THE DONOVAN
1055 RICHARDS STREET
VANCOUVER, BC
PROPERTY CONDITION
ASSESSMENT
FEBRUARY 25, 2011

OMICRON PROJECT NO. 10-10-221

PROPERTY CONDITION ASSESSMENT
1055 RICHARDS STREET
VANCOUVER, BC

**Re: Property Condition Assessment
1055 Richards Street, Vancouver BC**

PHOTO A-3

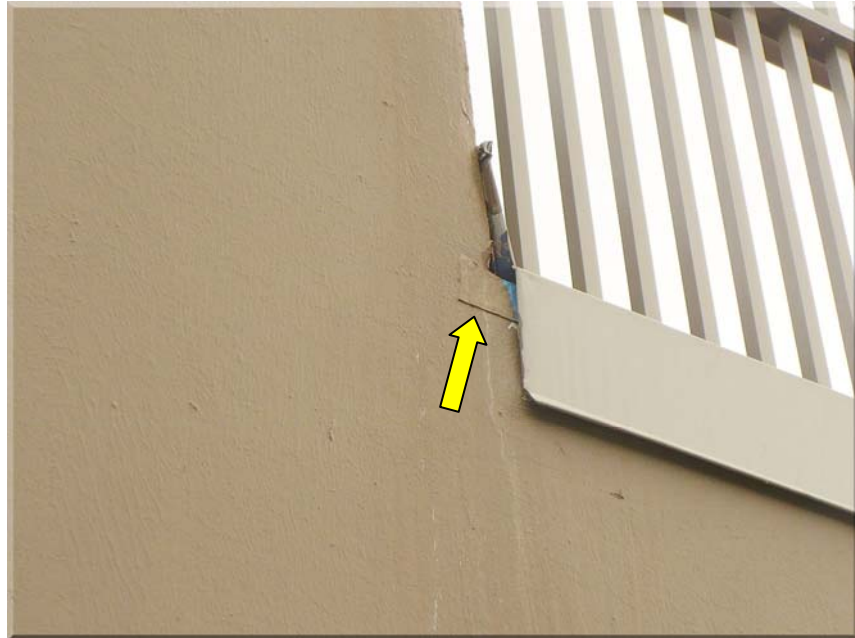
- 2.3 There is a cracked concrete paver on one penthouse deck (**Photo A-2**); **replace cracked paver.**
- 2.4 Saddle transitions have been detailed with self-adhered membrane (SAM) extending up the wall with metal flashing installed above. The SAM extends beyond the flashing in at least one location and has been inappropriately painted (**Photo A-3**). Metal flashings have been wrapped around the wall at a few locations. Saddle flashings have been typically left open at the edge (**Photo A-4**). It is inappropriate to leave SAM exposed and to leave open edges at flashings. **We recommend installing pre-formed prefinished metal closure wrap that extends around the wall with a gum pocket to receive caulk at returns to the face of the wall.**

Exposed membrane
at saddle flashing.

PHOTO A-4

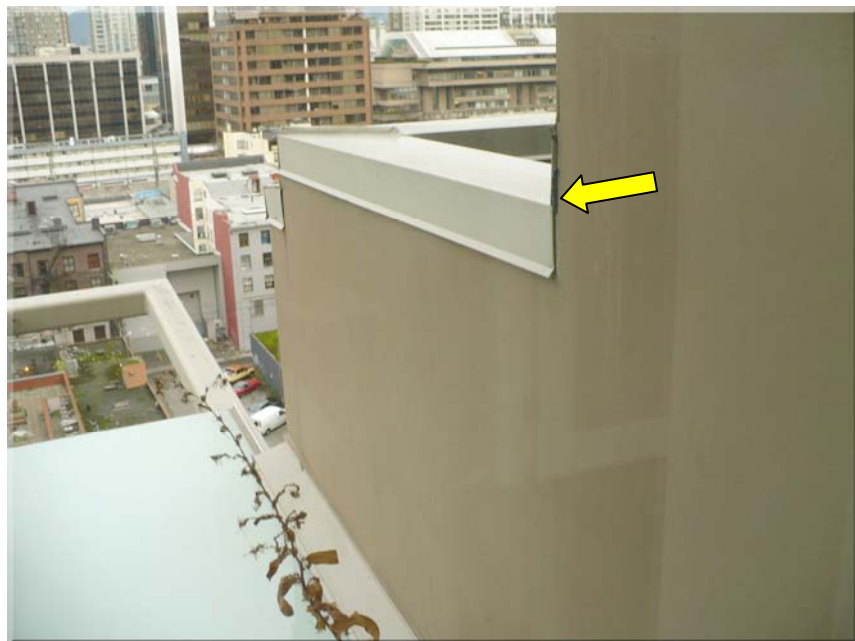
Typical open edge at
prefinished metal
saddle flashing.

PHOTO A-7

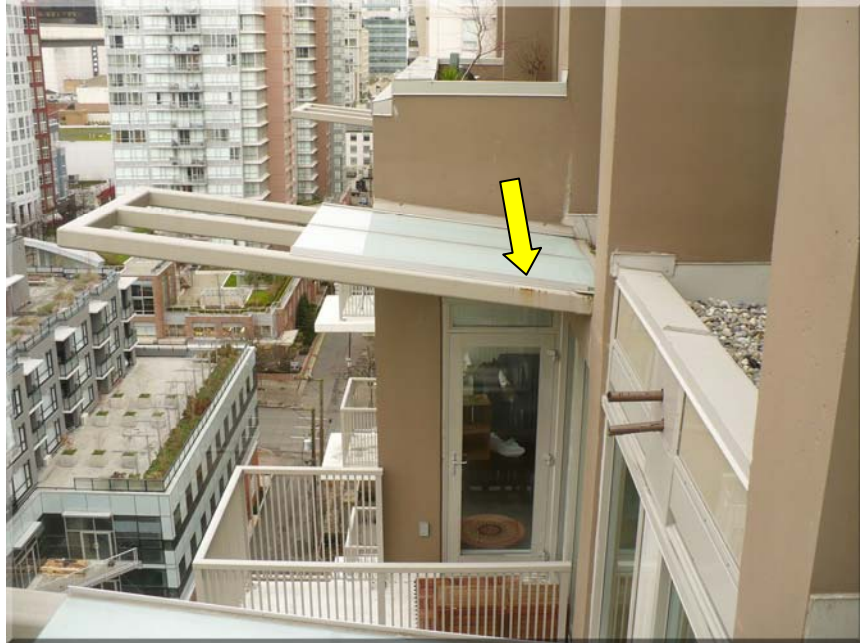
- 2.8 There are glass canopies on steel frames on floor levels 5, 15 & 17, at building entrances and at the townhouse entrances. Drawings indicate laminated tempered safety glass. Corrosion was observed at several locations on the steel frames (**Photo A-7**). **We recommend grinding off the corrosion, treating of the bare metal with zinc rich paint and then repainting the canopies.** There is a gap between the canopy and the wall allowing water to drain through at some locations (**Photo A-8**); whereas, some locations have been flashed and caulked. The structural connection of the canopy frame was observed to be corroded on townhouse canopies that lacked flashings; **clean corrosion and repaint damaged steel structure.** Drawings indicate a flashing and gumlip detail to prevent water from passing through; **we recommend installation of flashing and gumlip as per drawings.** The main entrance canopies appear to have been constructed according to drawings reviewed; however, there is a large gap between the wall and the canopy which allows rain water to fall on the intercom panel (**Photo A-9**). Although not a deficiency, **we recommend installing a transition flashing from the canopy to the wall face c/w with gum pocket to receive sealant at the wall face.**

Typical corrosion on canopy frame.

PHOTO ELEV-5

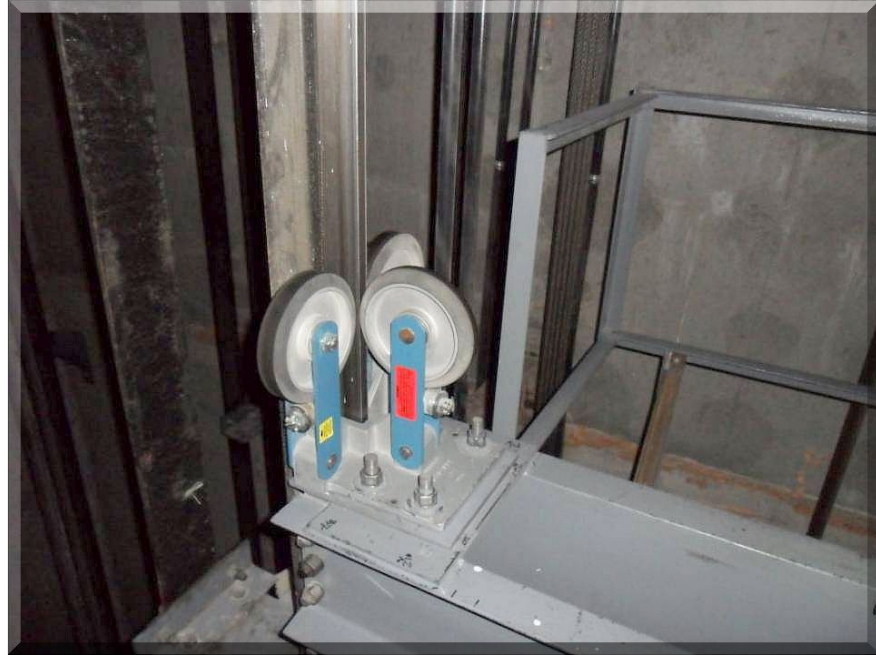
- 5.6 Repairs and improvements in the maintenance practices of the elevator maintenance contractor are required. The items noted are part of the annual maintenance contract. **These include repairs to the car roller guides**

(Photo ELEV-5), incomplete brake data tags (Photo ELEV-12), missing door gibs, seismic motion switch (Photo ELEV-13) in error state and a trouble indicator on the elevator lobby telephone (Photo ELEV-7). These items should be addressed by the elevator maintenance contractor and/or telecommunications contractor.

PHOTO ELEV-16

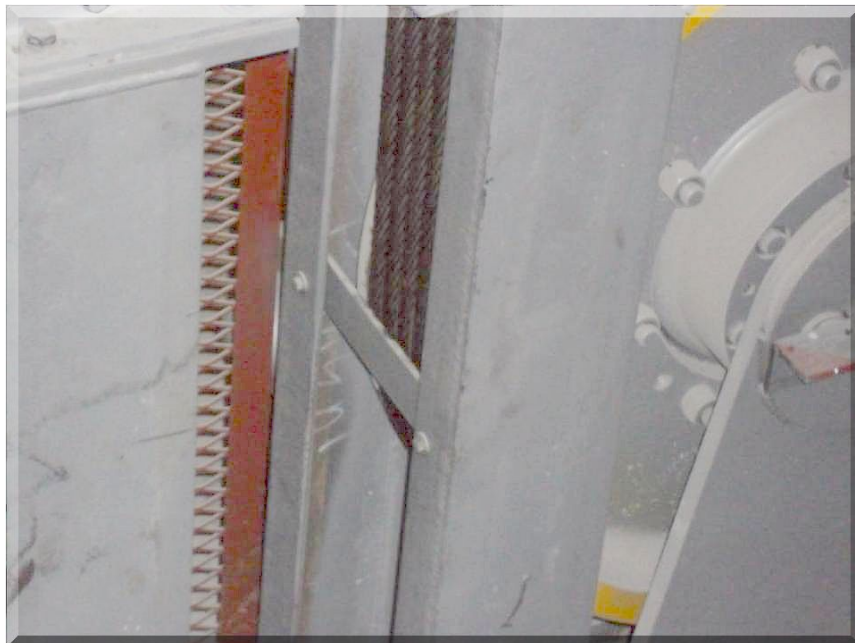
- 5.8 **The seismic rope retainer guards on the elevator machines are not code compliant and should be replaced with compliant guards to retain the ropes in position in the event of an earthquake (Photo ELEV-16).** We believe this was issued as a BC Safety Authority directive against the equipment at the time of construction completion and in our opinion this has not been completed satisfactorily by the elevator contractor.

Non compliant
seismic rope guards.
